Lakes & Waterways Advisory Board

May 9, 2017 12:00 noon

Shoreline Alteration Permit Application Staff Report (Dock/Boathouse)

Application #: 17:01

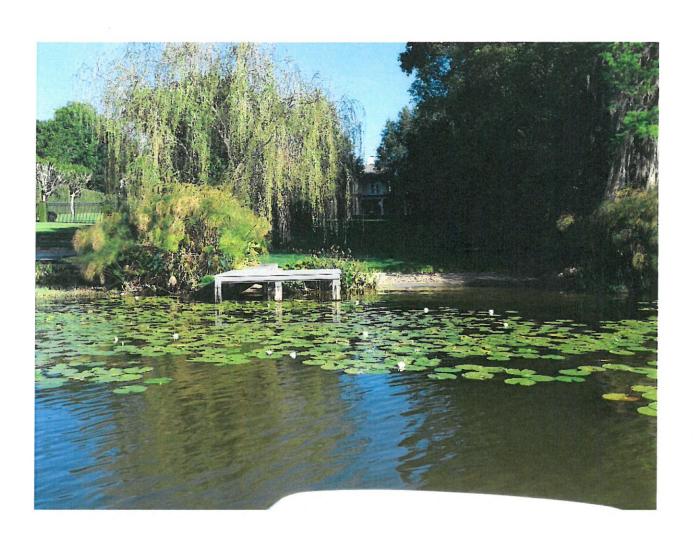
On the Plan View drawing, please change the term "Shoreline" to "OHW" or "Ordinary High Water" and show the elevation of 66.5 (NGVD) or 65.7 (NAVD).

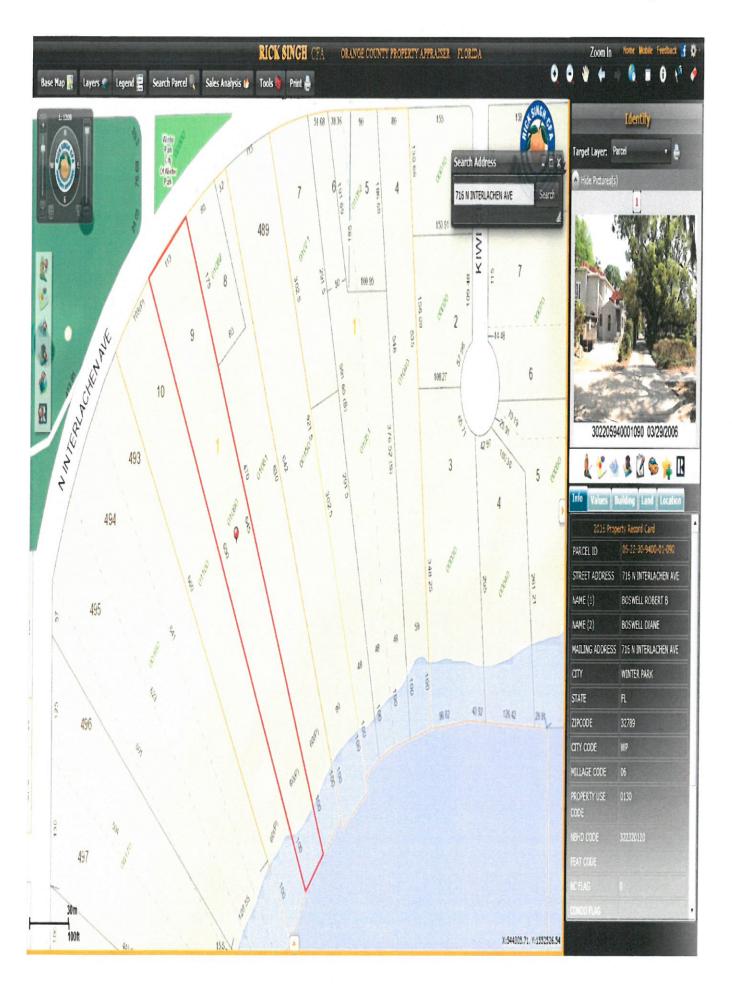
On the construction detail sketch, the bottom of the roof is shown at 11' above the deck. Please revise to show the peak of the roof no higher than 11' above the deck.
